Informal document GRSP-59-15-Rev.1
(59th GRSP, 9-13 May 2016,
agenda item 14)

Proposal for Supplement 12 to the 04 series of amendments to Regulation No. 44 (Child Restraint Systems)

Submitted by the expert from Consumers International

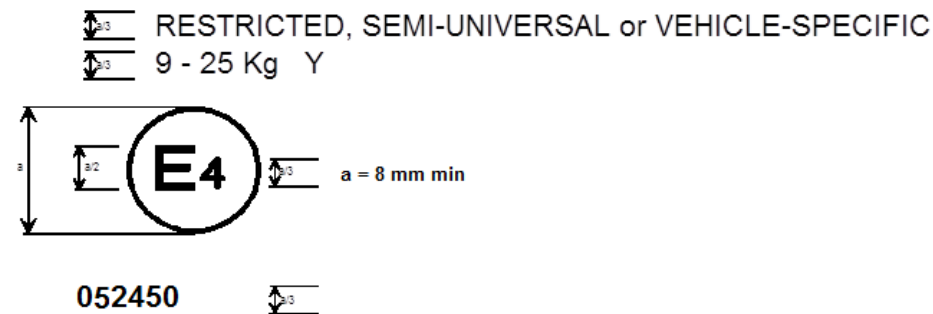
Annex 2, amend to read:

The child restraint system bearing the above approval mark is a device capable of being fitted in any vehicle and of being used for the 9 kg-36 kg mass range (Groups I to III); it is approved in the Netherlands (E 4) under the number 052439. The approval number indicates that the approval was granted in accordance with the requirements of the Regulation concerning the approval of restraining devices for child occupants of power-driven vehicles ("child restraint system") as amended by the 05 series of amendments.

The child restraint system bearing the above approval mark is a device not capable of being fitted in every vehicle and of being used for the 9 kg-25 kg mass range (Groups I and II); it is approved in the Netherlands (E 4) under the number 052450. The approval number indicates that the approval was granted in accordance with the requirements of the Regulation concerning the approval of restraining devices for child occupants of power-driven vehicles ("child restraint system") as amended by the 05 series of amendments. The symbol "Y" indicates that the system contains a crotch strap.
